Safety Services

HAZARD ALERT EQUIPMENT OR LINE TAP CONNECTOR – 59-1401

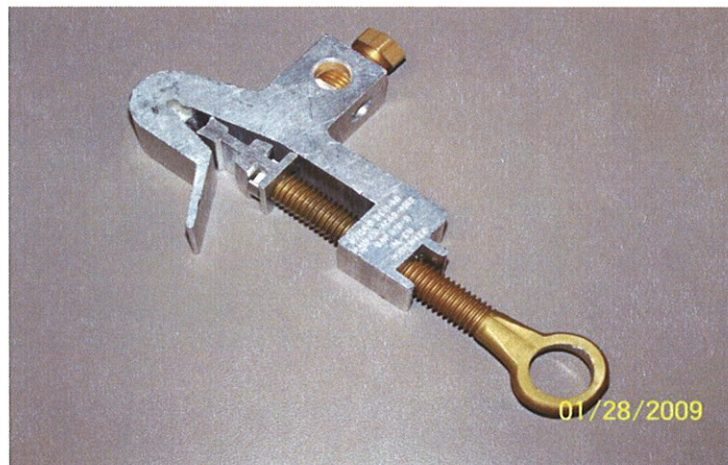
59-1401 the Utilco Power Grip is not to be used on a run conductor of #4 until further notice.

Although listed for use on #4 it does not appear to fit. The manufacturer has been contacted to determine cause & resolution.

Substitute 59-1400 Hot line clamp range #6 to #2/0.
